NUMBER: 18-037-04

Flash: Fuel Economy Improvement, White Smoke On Start Up, Accuracy Of Fuel Mileage In Overhead Console Display

This bulletin involves erasing and reprogramming the Cummins ECM with new software.

2004 - 2005 (DR) Ram Truck

Fig. 2 AUTHORIZED MODIFICATION LABEL

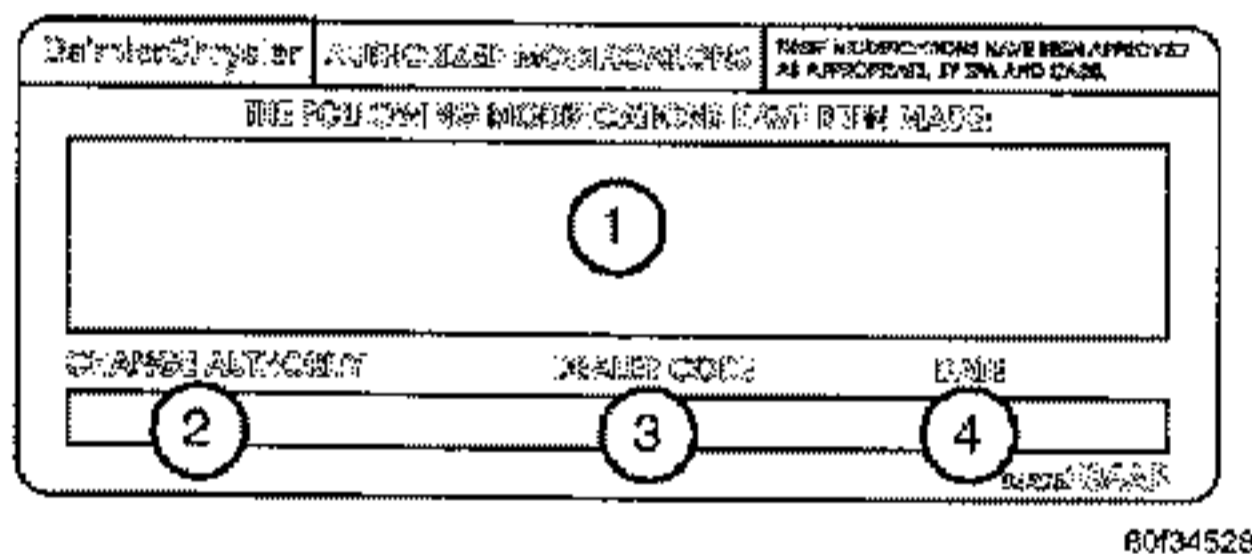
- 27. Type the necessary information on the "Authorized Modification Label" p/n 04275086AB and attach near the VECI label ().

- 1 - ENGINE CONTROL MODULE P/N (INSERT P/N) USED
- 2 - CHANGE AUTHORITY: TSB XX-XXX-XX
- 3 - DEALER CODE: XXXXX
- 4 - DATE: XX-XX-XX
